ADDENDUM NO. 2

Three Rivers Community Schools – New Transportation Facility
58420 Haines Road
Three Rivers, MI 49093

A/E Project 5-5138

ADDENDUM 002

4 DISPATCH DESK DETAIL
1 1/2" = 1'-0"

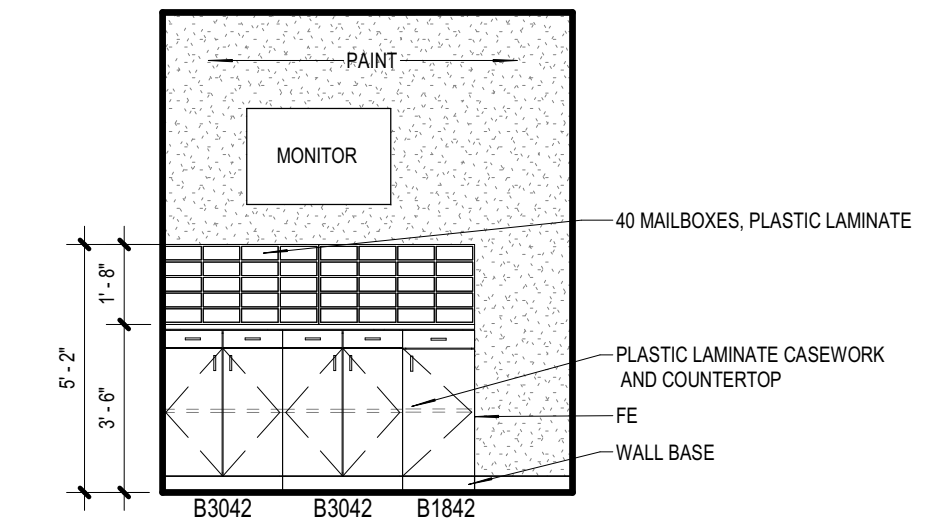
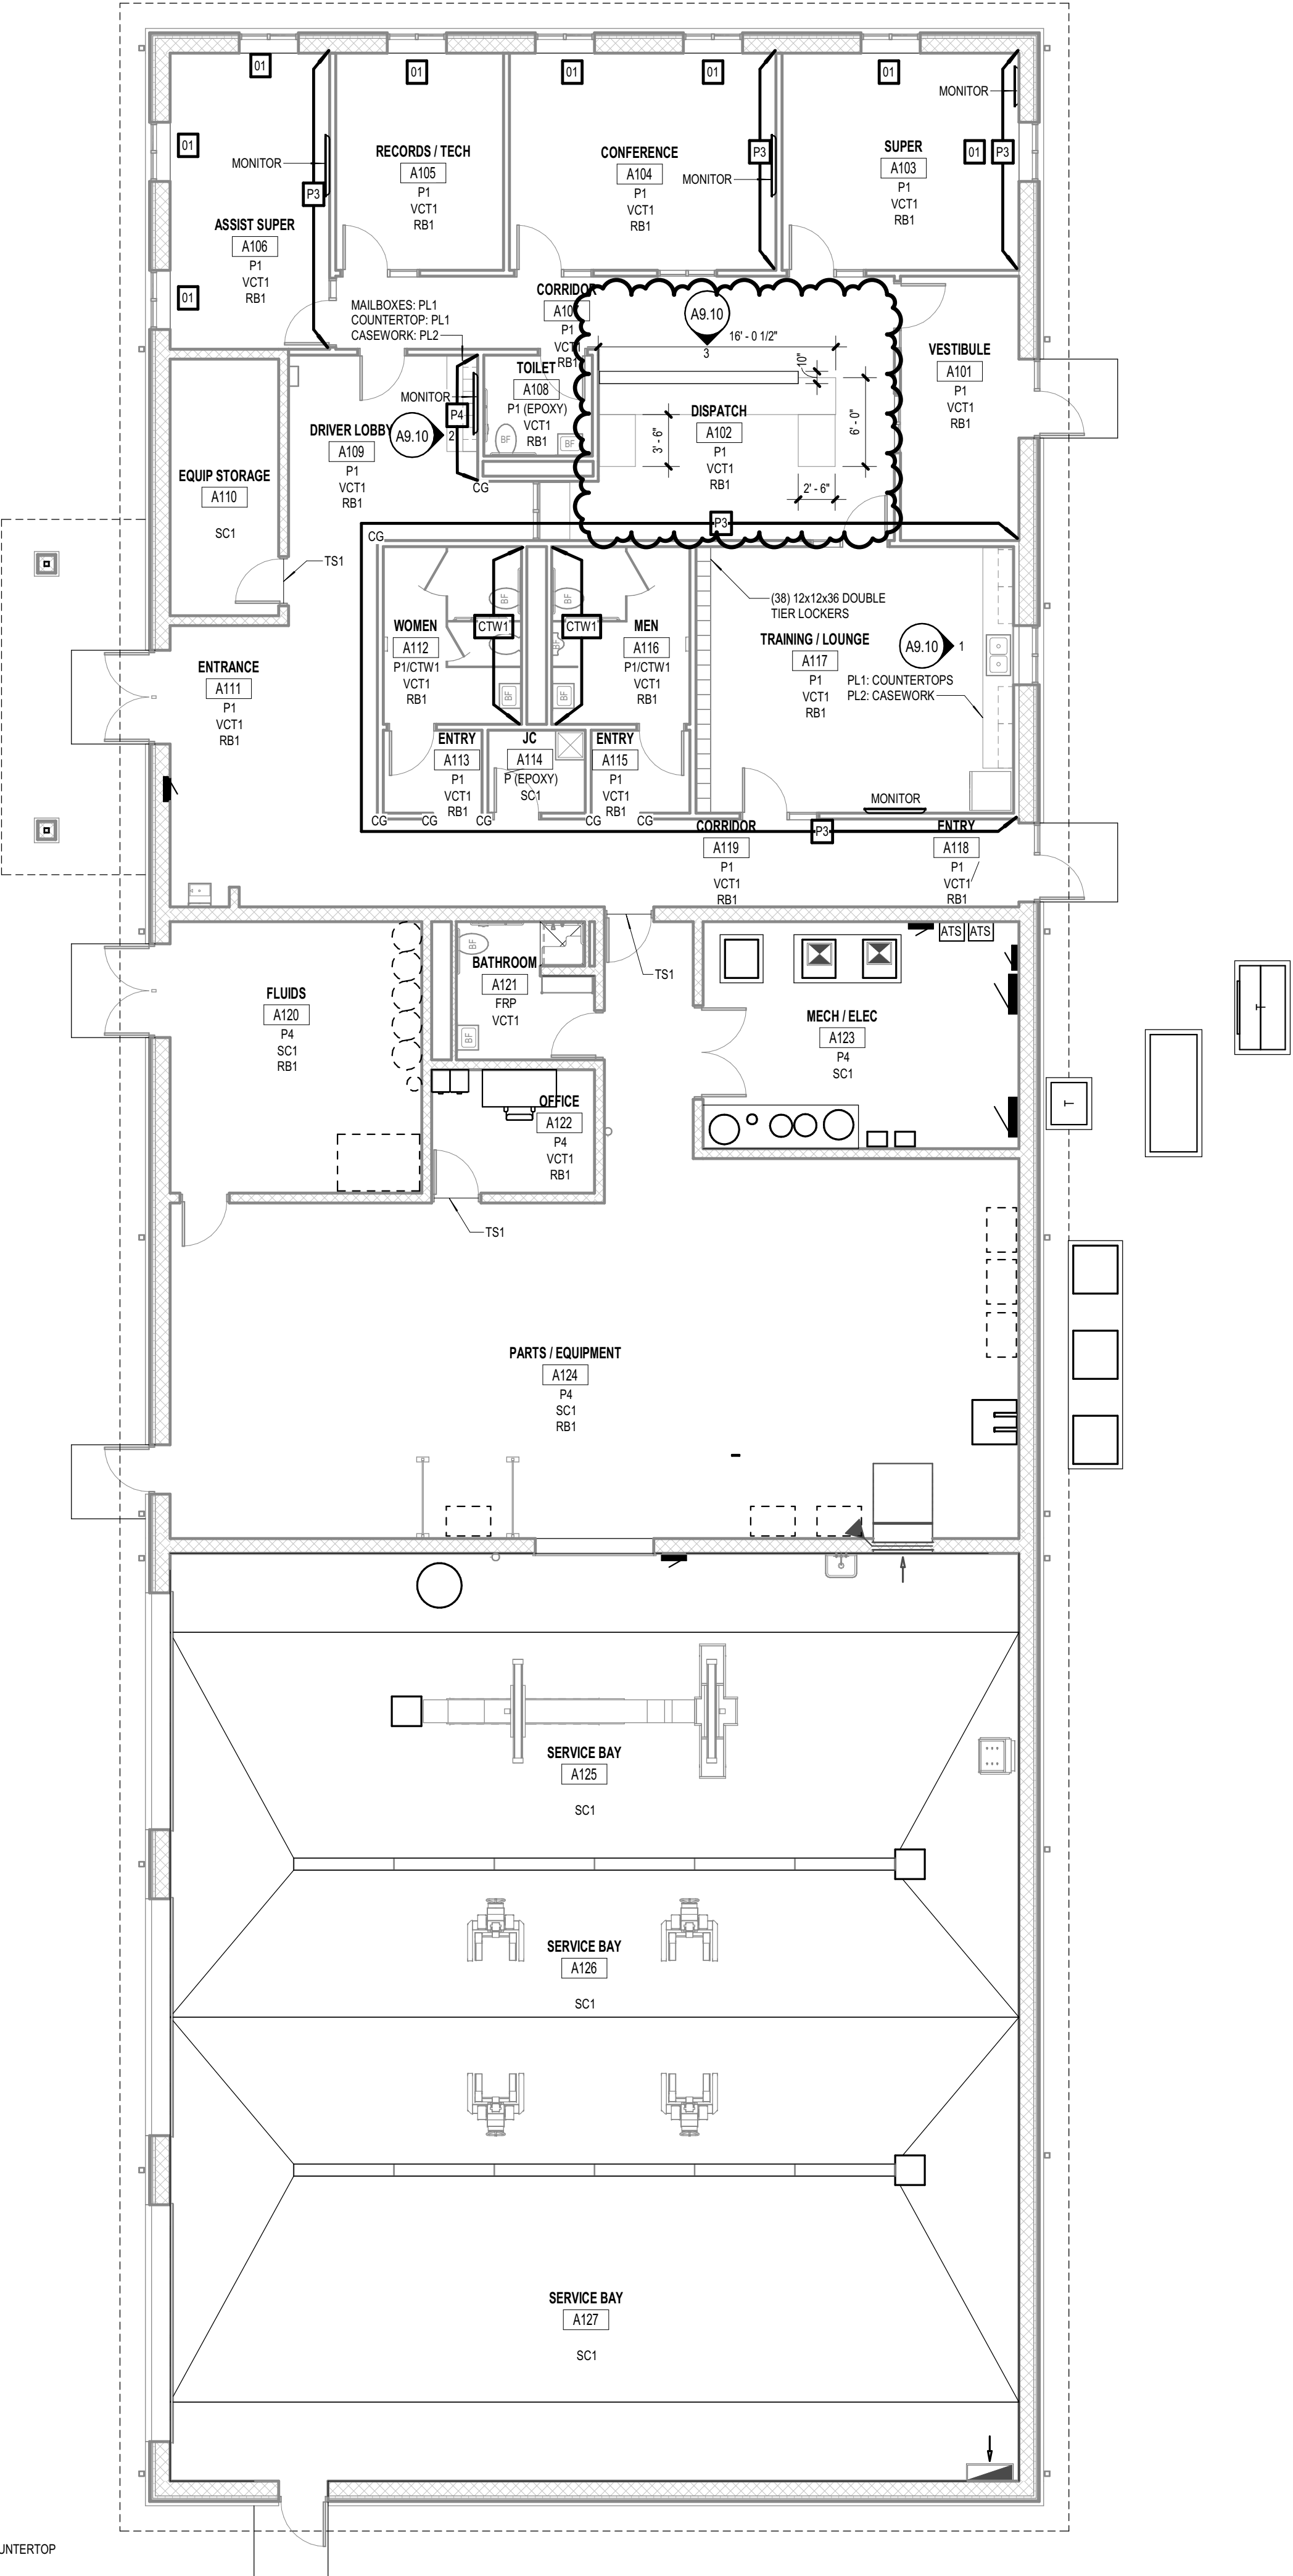
ITEM NO. 7 SHEET A9.10 – FINISH PLAN AND INTERIOR ELEVATIONS (REISSUED)

- A. Refer to the plan/section for changes to Dispatch Desk dimensions.
- B. Finish information was added to the finish legend.

E2.10

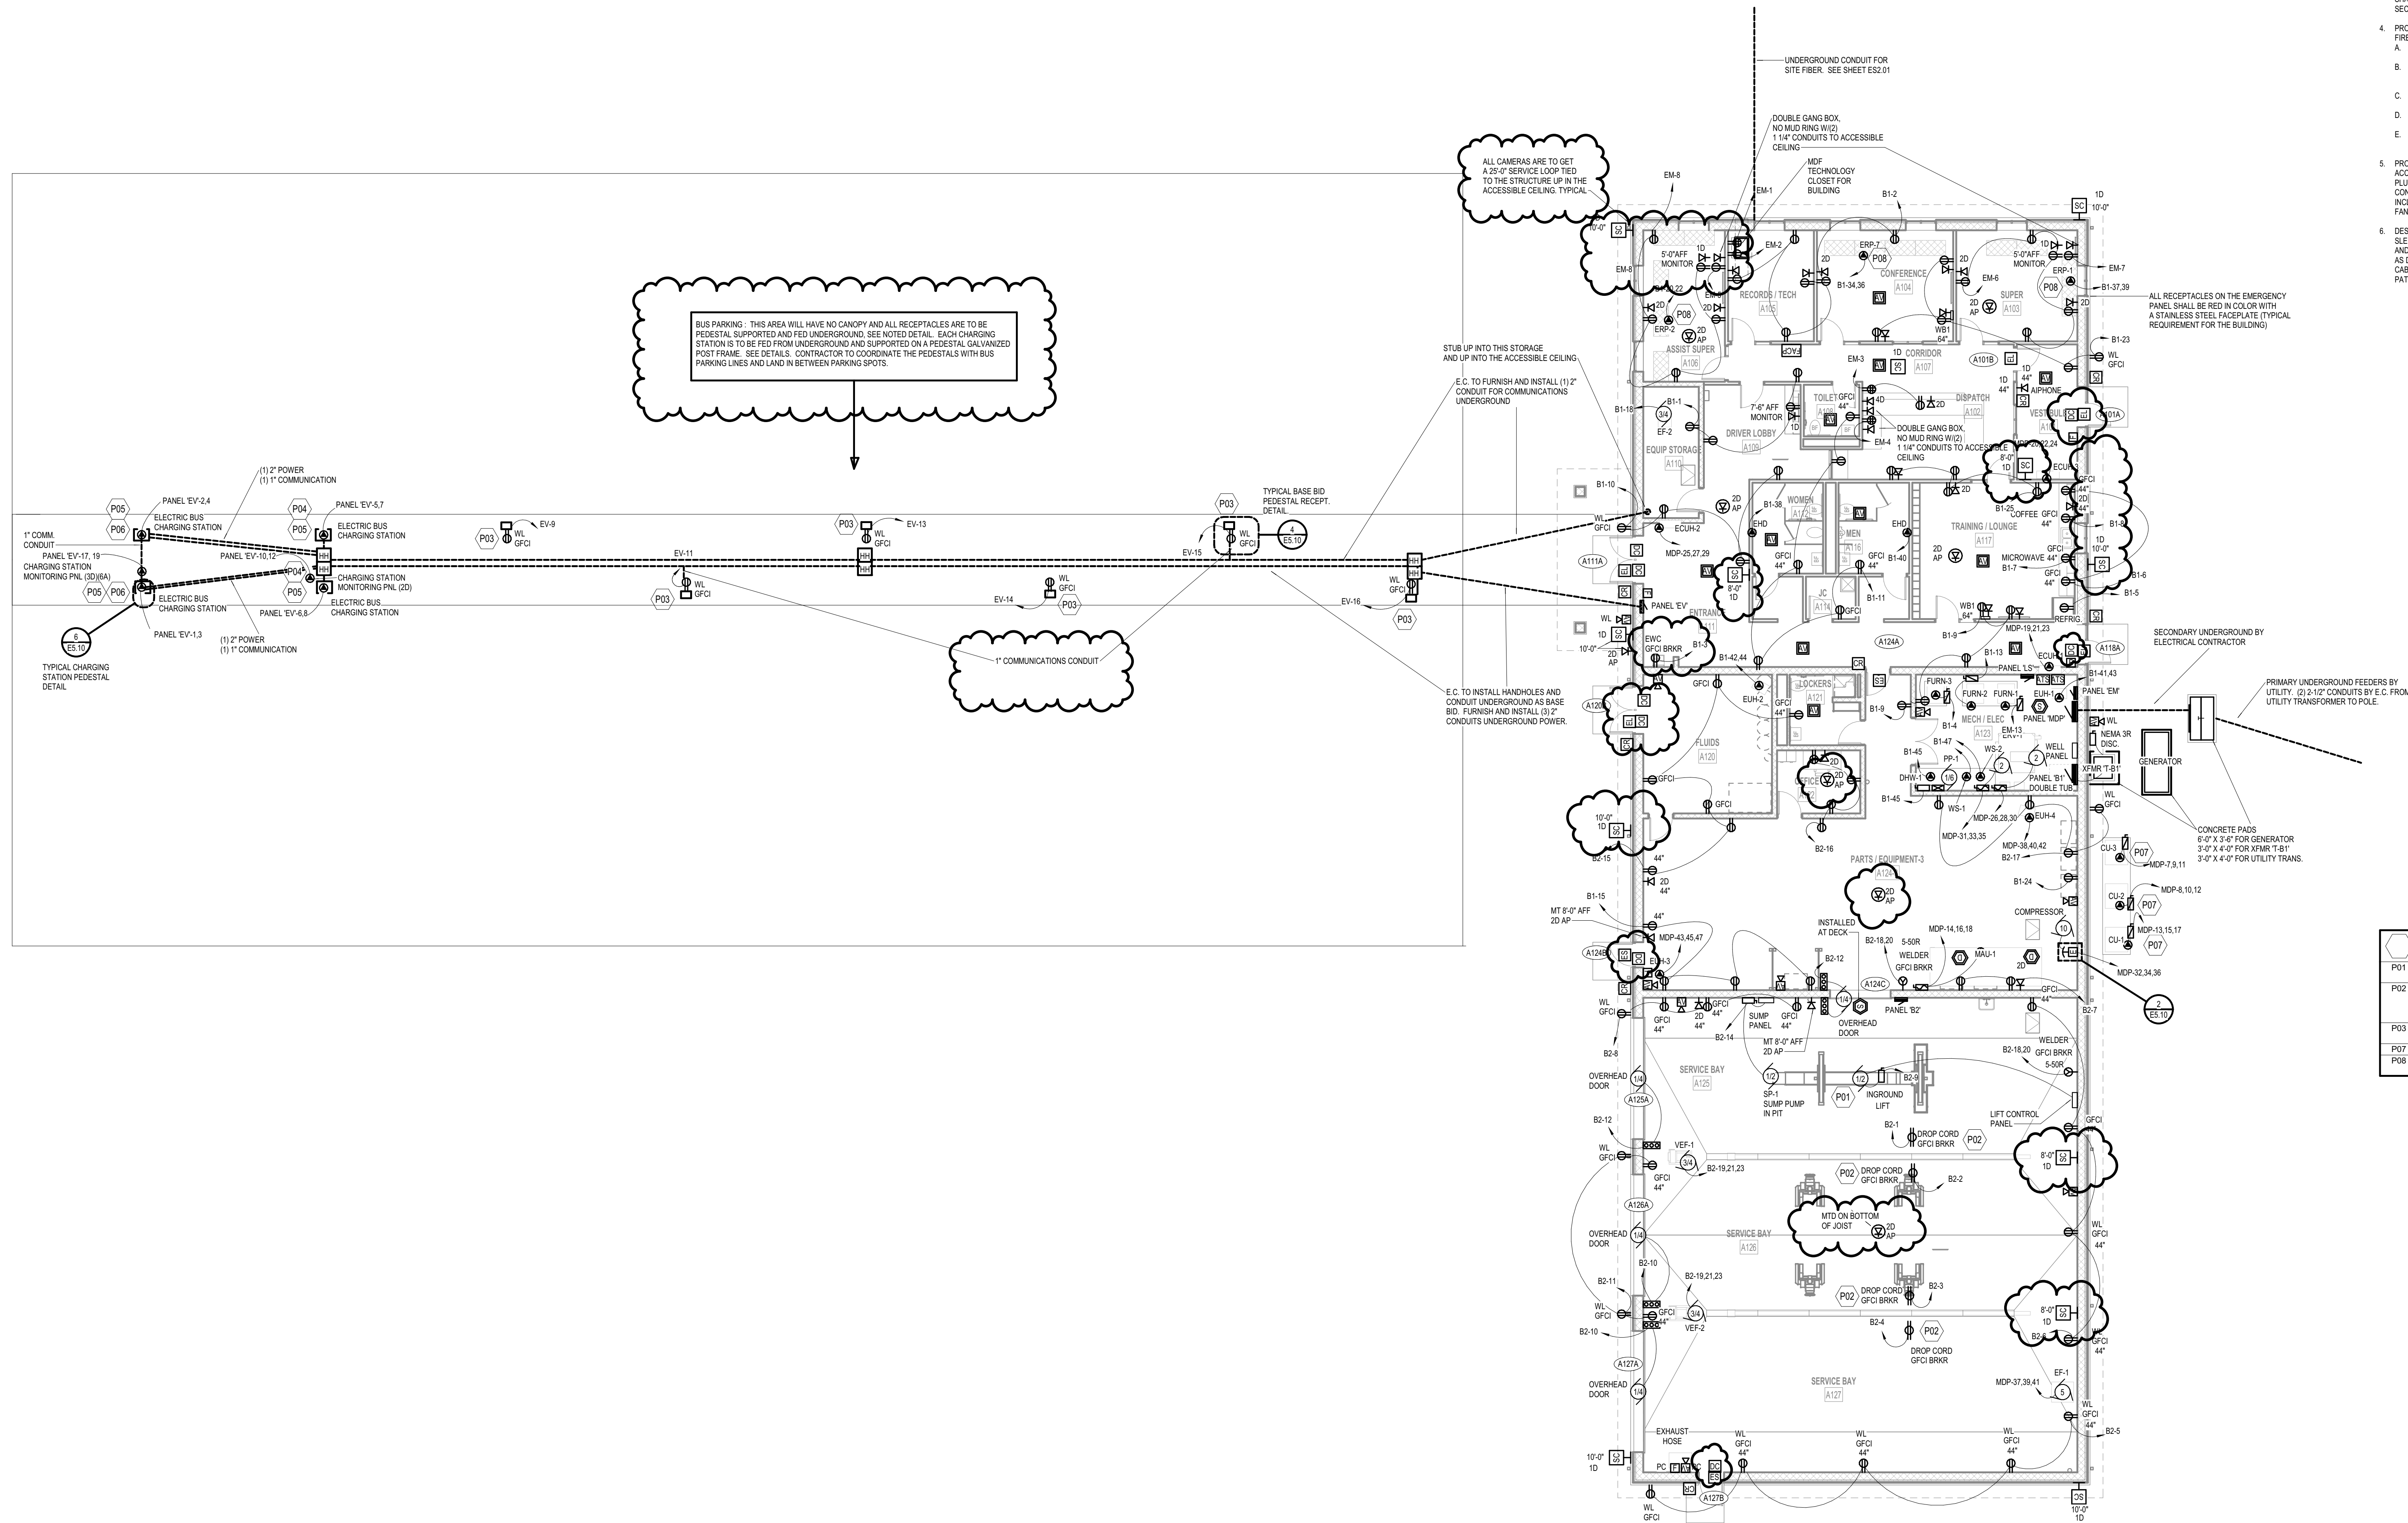
ITEM NO. 9 SHEET E2.10 – FIRST FLOOR POWER & COMMUNICATIONS PLAN (REISSUED)

- A. Refer to the plan for the removal of the underground conduit and handhole running west out of the building from Records/Tech A105.
- B. Refer to the plan for an added camera and access point in Service Bays.

- C. Refer to the plan for an added camera outside of Parts/Equipment and added access points for Parts/Equipment and office.
- D. Refer to the plan for all exterior doors to have door contacts. E.C. required to furnish and install raceways into the door frame and building access system wiring.
- E. Refer to the plan for a security camera relocation outside and two security cameras added inside of the office area.
- F. Refer to the plan for the circuit to be added to the EWC.
- G. Refer to the plan for the typical note for all cameras to have a 25'-0" service loop.
- H. Refer to the plan for the updated note for the bus parking area and parking coordination with pedestals and bus parking.
- I. Refer to plan for data drops for access points to be removed from pedestals.
